GS# 103-317
University Pointe – Buildings 100 & 200
Jackson State University
Project Number: 2017-006

Addendum No. 2

14May2026

A-402R 1

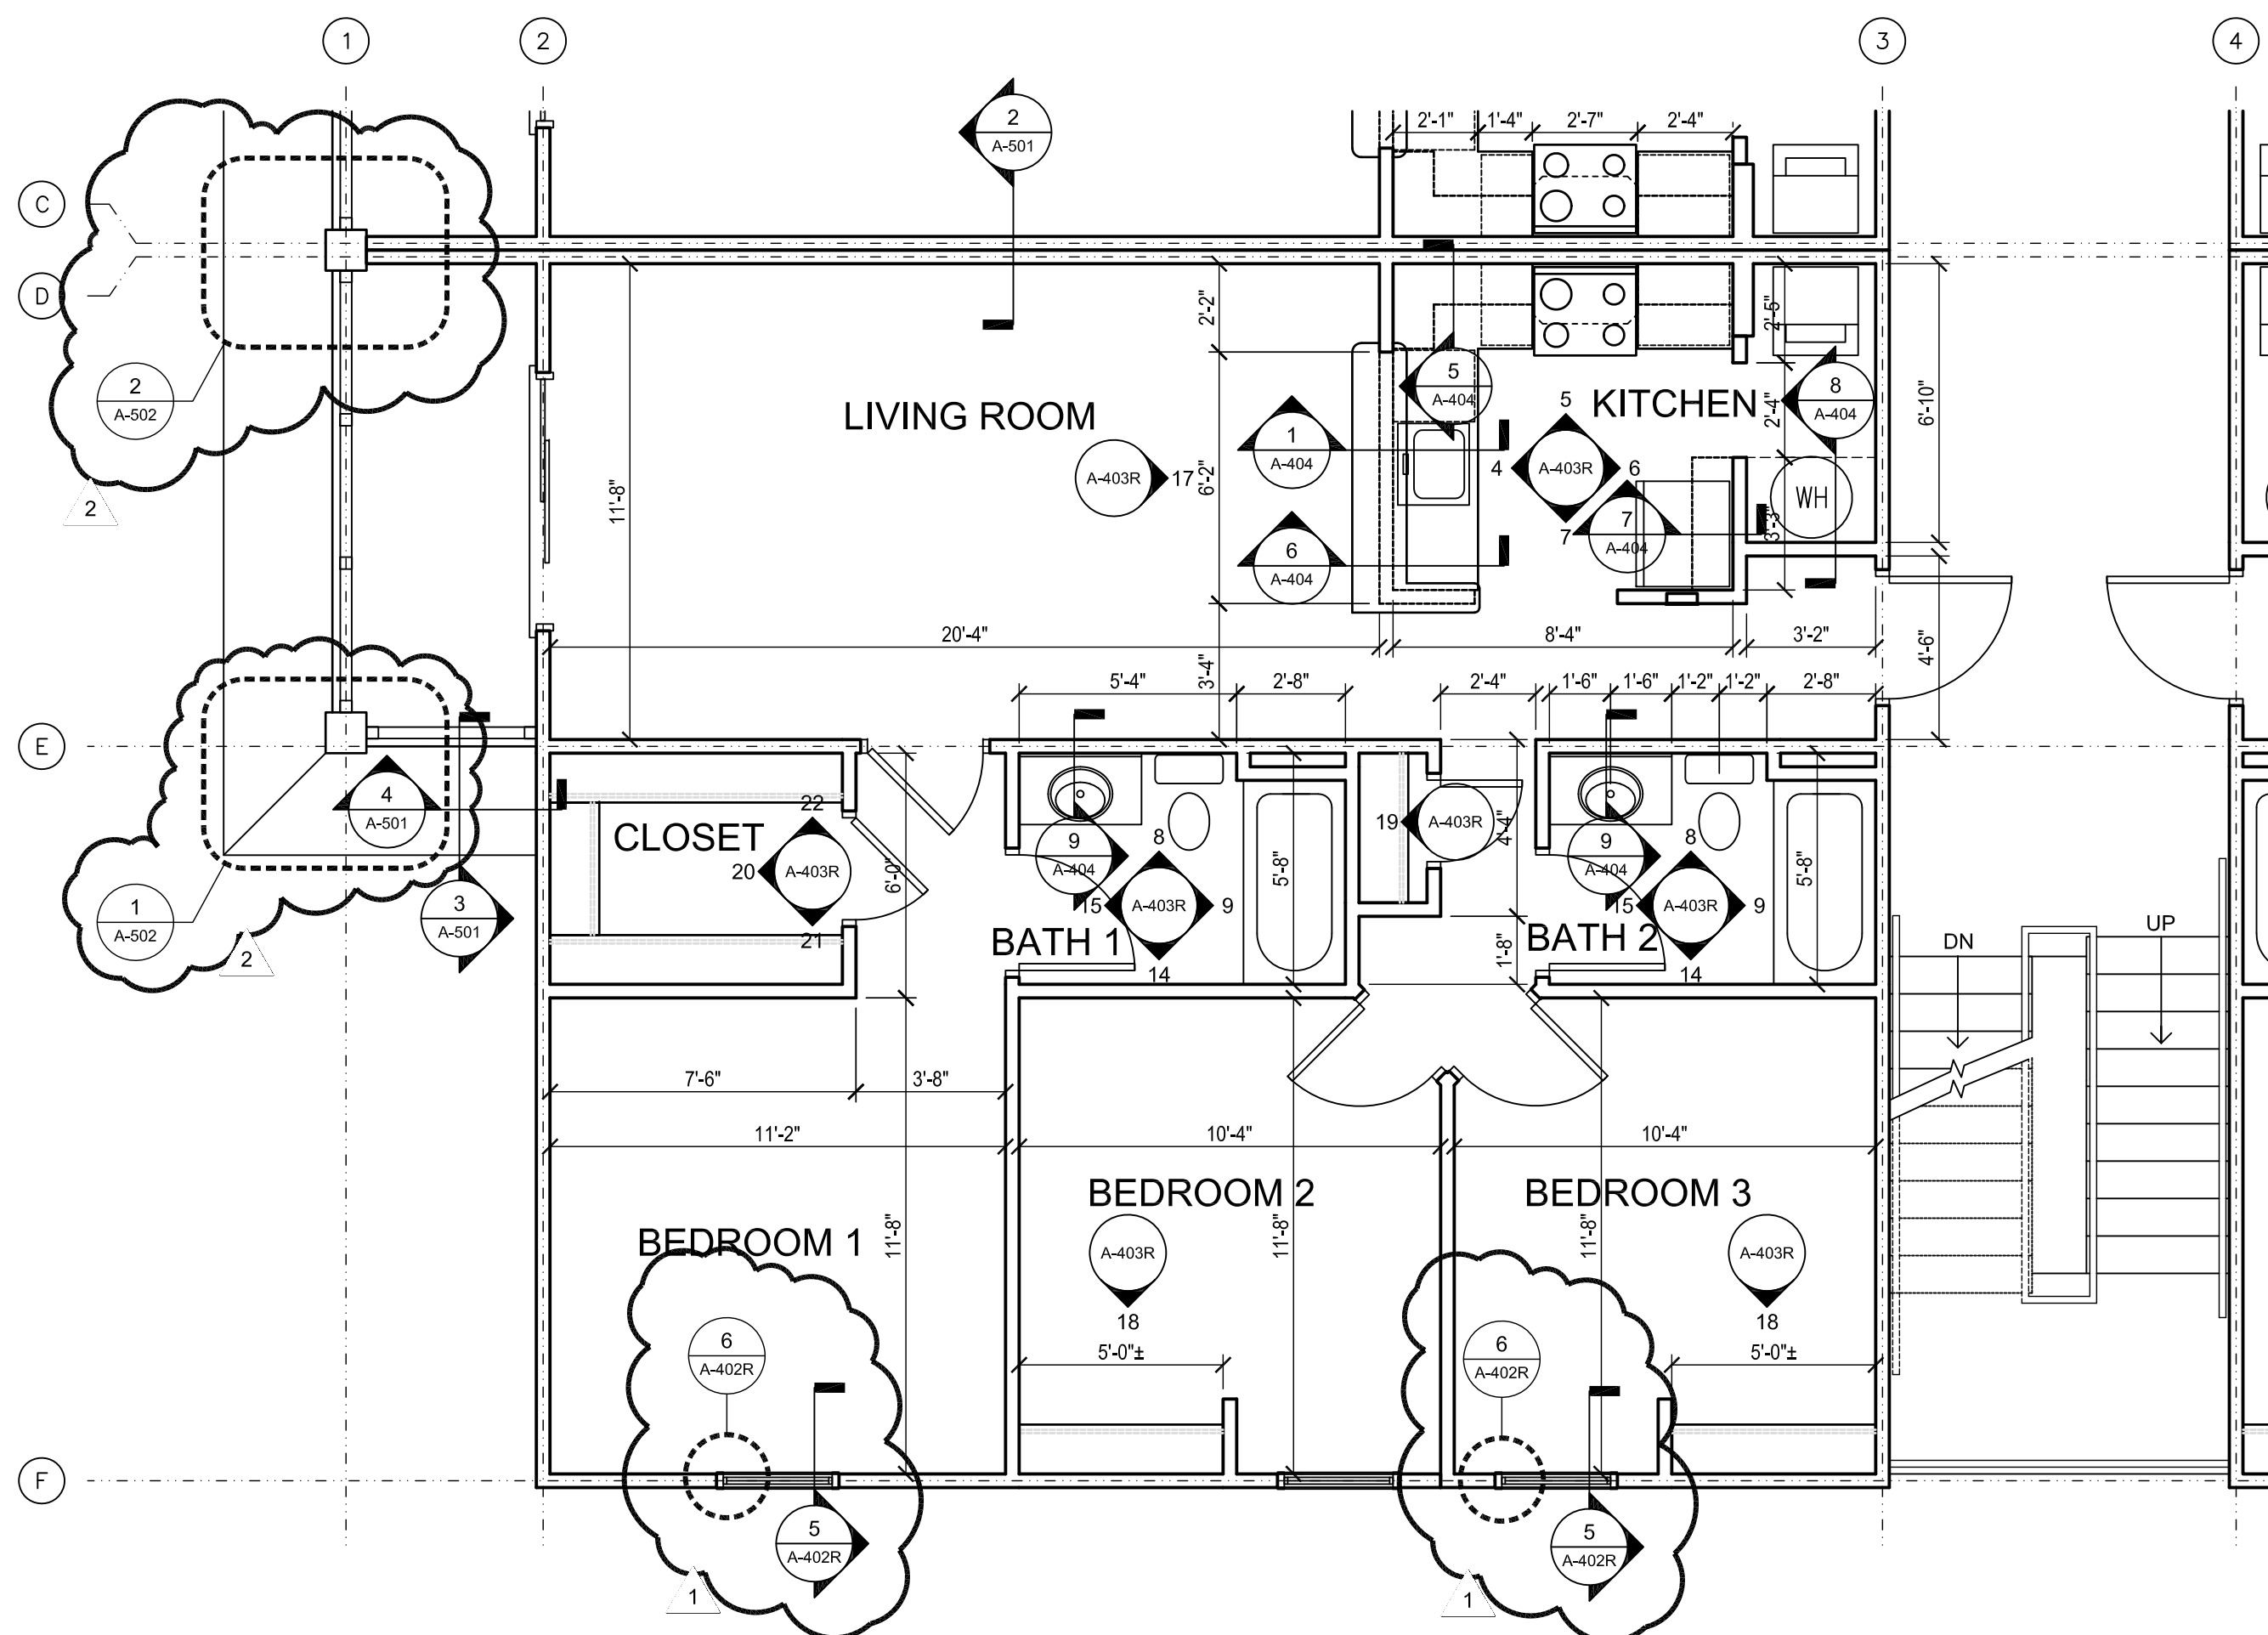
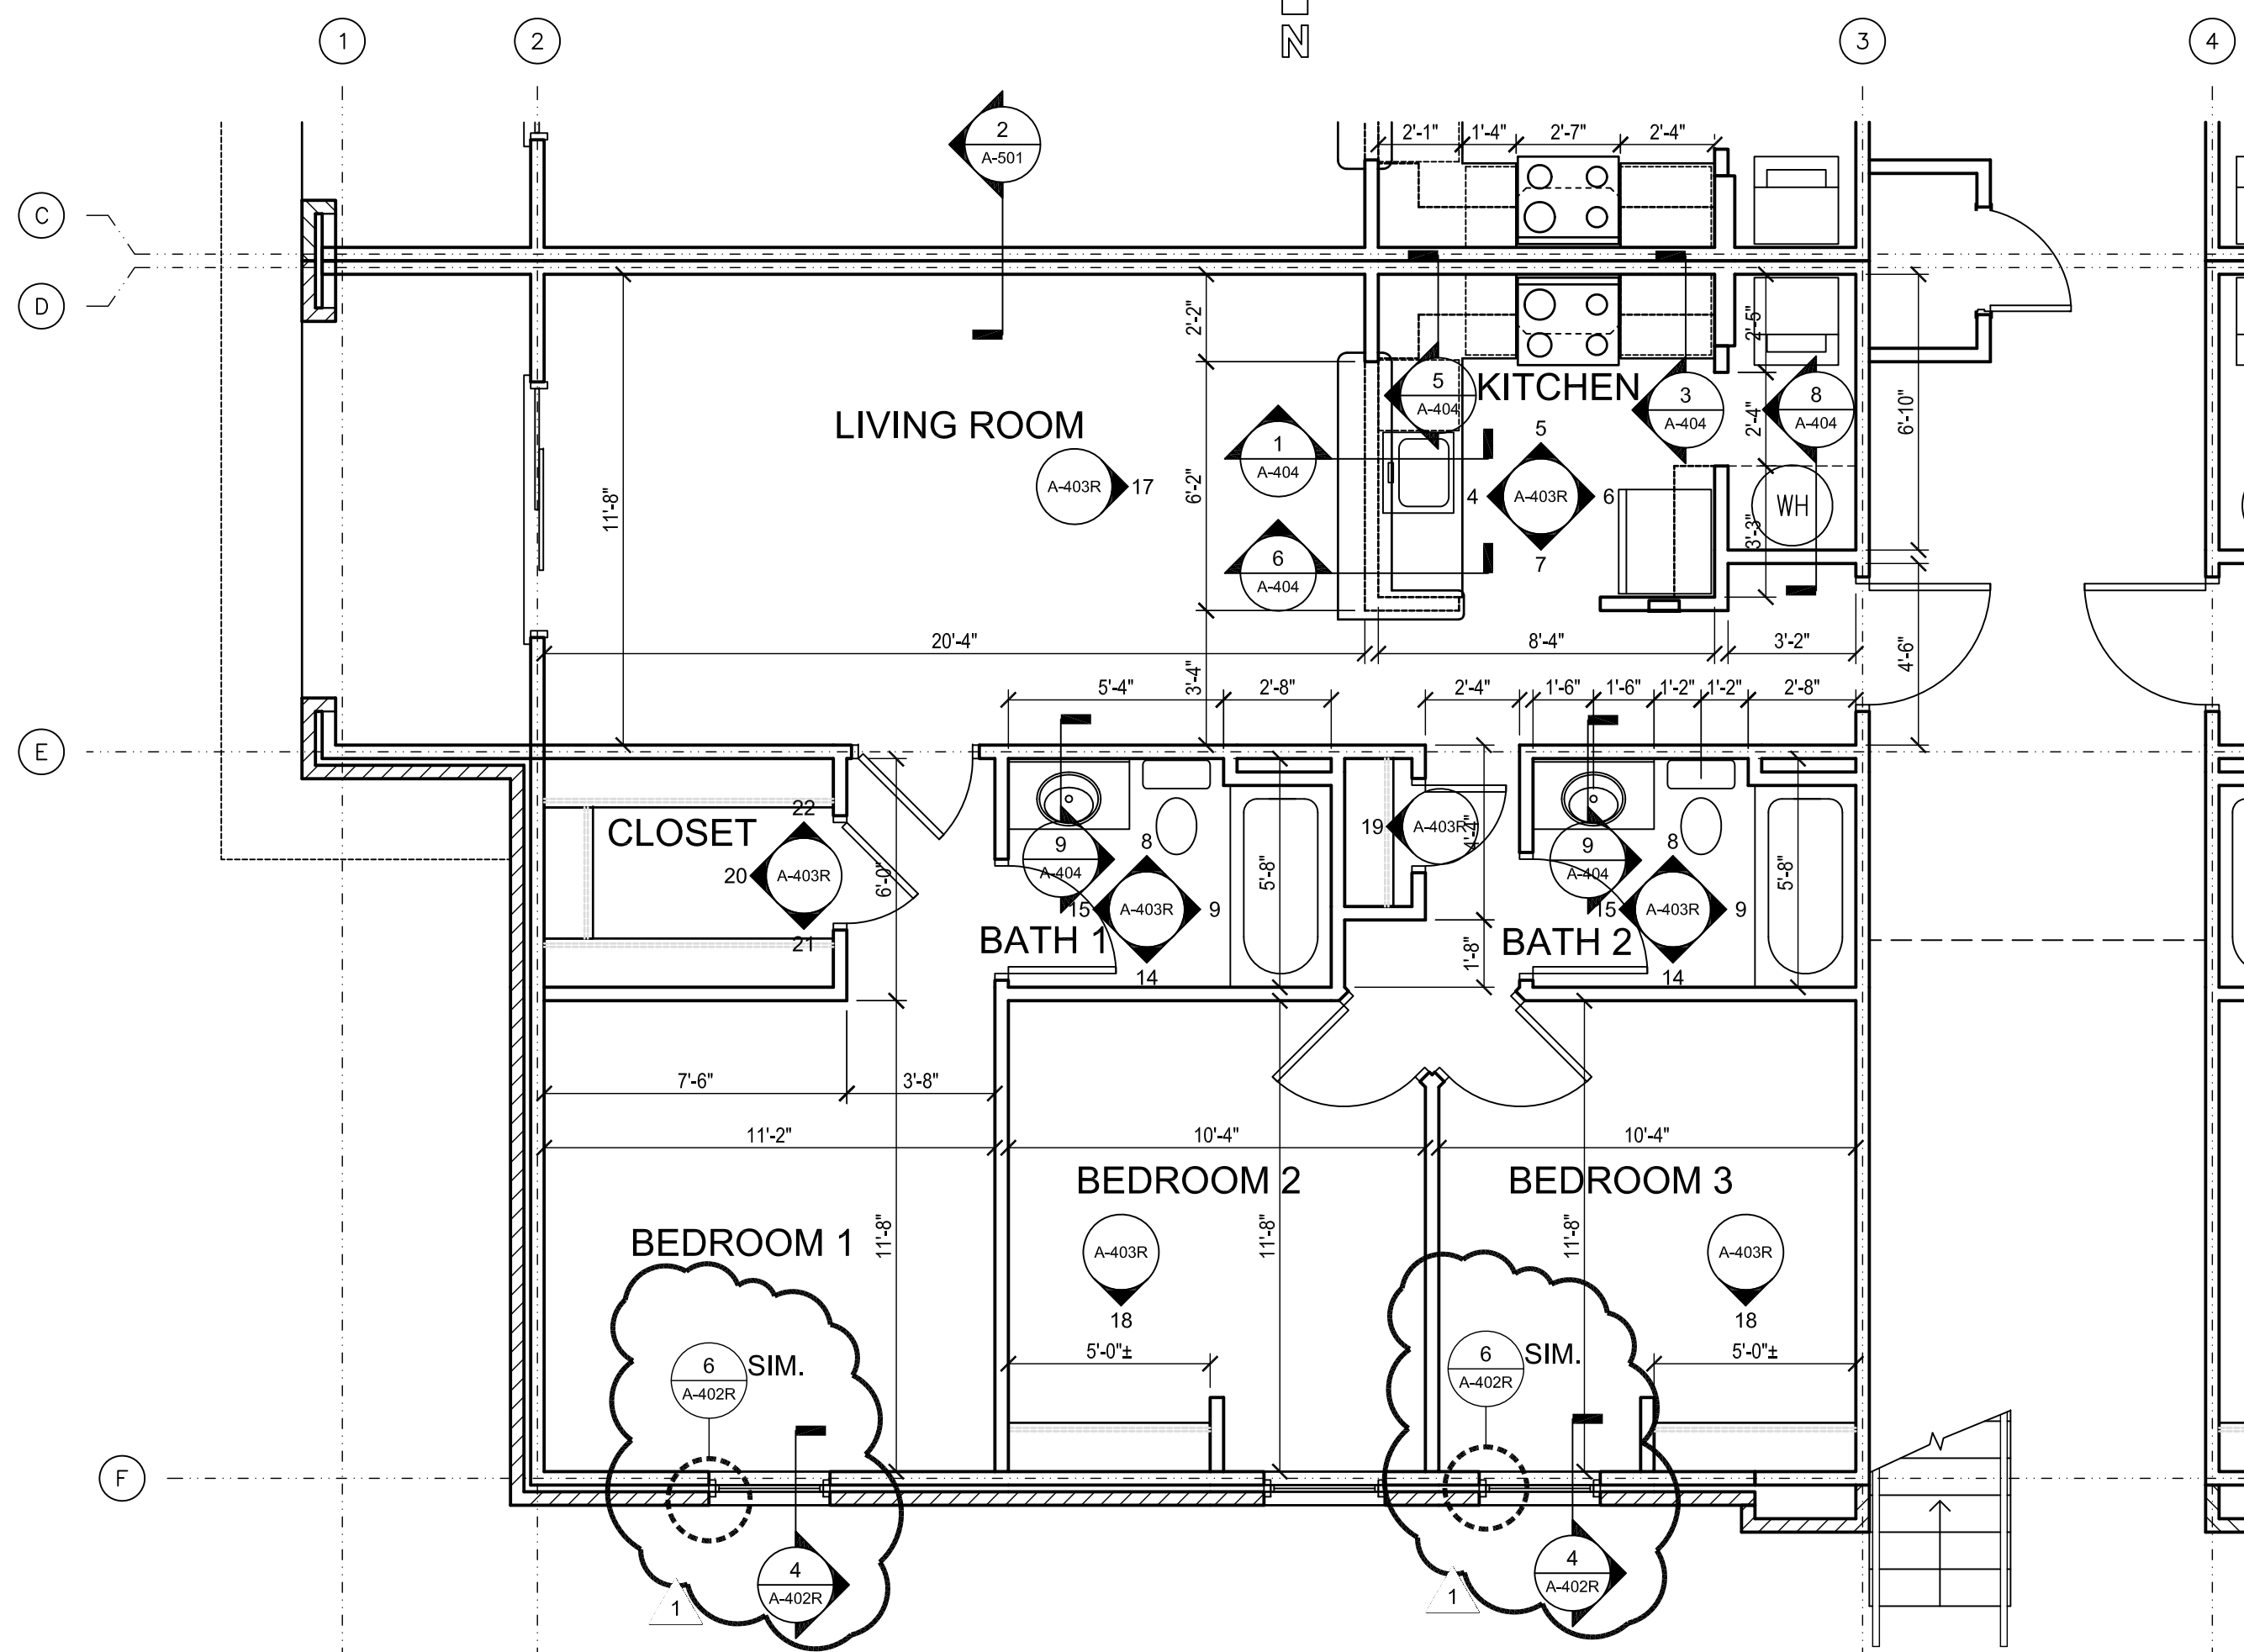
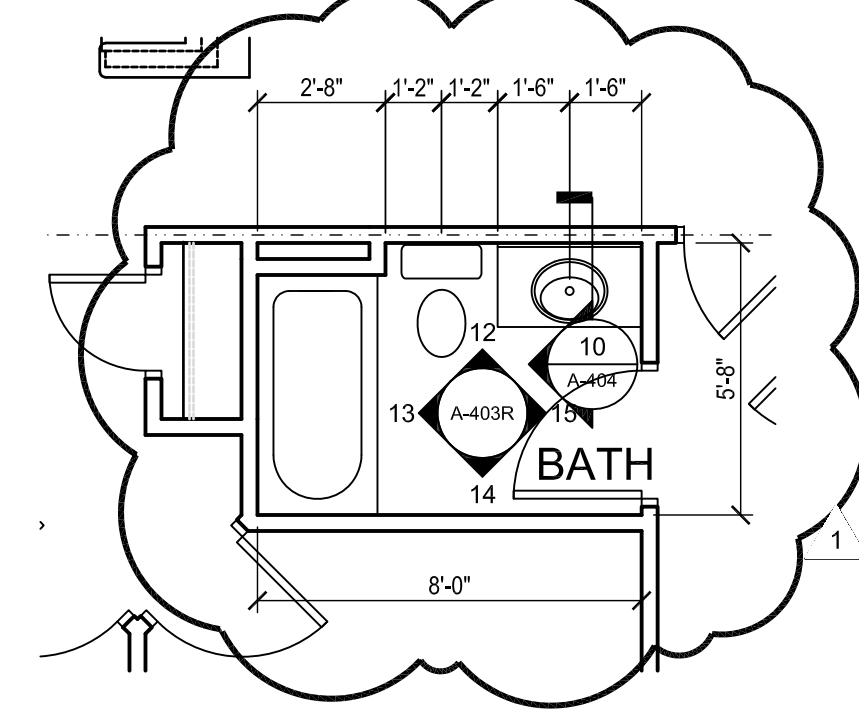
- Item No. 9 Sheet A-502.
- Add: A new drawing sheet has been created which will include details for the retrofitting of the balconies at building 200.
- Item No. 10 Sheets A-401R1 & A402R1.
- Revision: Revise paint sheen finish from Flat to **Eggshell** finish.
- Item No. 11 Sheets A-601R1 & A602R1.
- Revision: Revise door type “A” description from metal to wood.
- Item No. 12 Sheets T-101R
- Revision: Update the title sheet to include A-502 in the list of drawings.
